REVIEWER COMMENTS

Reviewer #1 (Remarks to the Author):

Supplementary Fig. 2 Conceptual flow chart of iron and steel flows. The symbols at the bottom right of the process show the associated coefficients; the three equations show scrap estimation formulas based on simple mass balance.

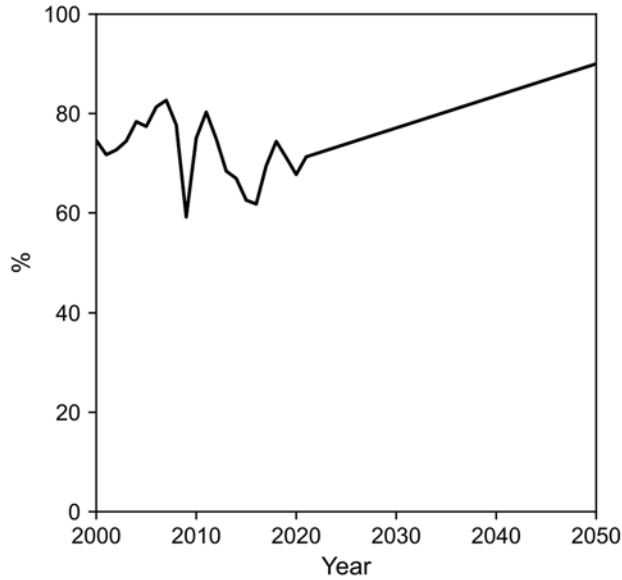
Fig 3: I am not an expert in modelling stocks and flows, but it does strike me as interesting/noteworthy to see such an increase in the Scrap-EAF route, which is mainly attributed (in my possibly limited understanding) to the availability of post-consumer scrap in your model. Similar to the comment right below, I think some more transparency about the underlying parameters in equation 8, their values and sources would be helpful to better understand if the values for the calculated post-consumer scrap and thus, the calculated CapEAF are reasonable.

Thank you for this insightful feedback. Indeed, our previous manuscript was not clear enough on this point. We have added the following two figures accordingly:
